Project Name: Washington Realtors BuildingMaster File: 16-9076

- ☐ Concept Design Review  
☐ Detail Design Review  
☒ Combined Design Review

Date: January 12, 2017

**CITY OF OLYMPIA**  
**BASIC COMMERCIAL DESIGN CRITERIA**  
**Chapter 18.110**

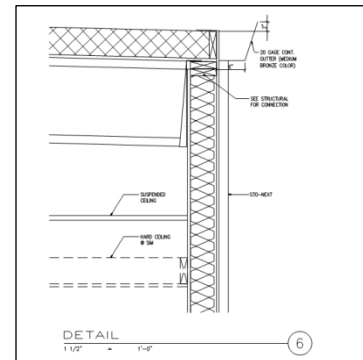
*The roofline uses a decorative cornice on all but a 110' section on the north elevation. Variation in height is provided at the southwest corner to emphasize the building entry. A round element projects above the roofline and as shown in the sections on sheet A4.1 and 2 (Attachment 4), is open to the floors below. The projecting window on the south elevation provides variation and relief along the upper portion of the building.*

*The roofline on the westerly 110' of the north elevation consists of a metal gutter. Additional variation and detailing will be needed to meet this design standard, such as decorative cornice or varying the height of the parapet. Adding such measures will also provide visual consistency around the building as required under OMC 18.110.140.*

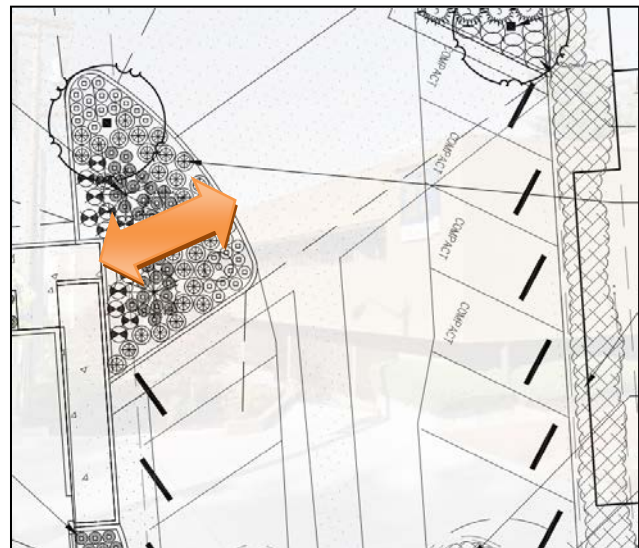
*Pedestrian access between the parking lot and building entrances is provided. Improved access from the diagonal stalls on the east side of the building can be achieved by providing a walkway through the planting bed at the northeast building corner (see arrow).*
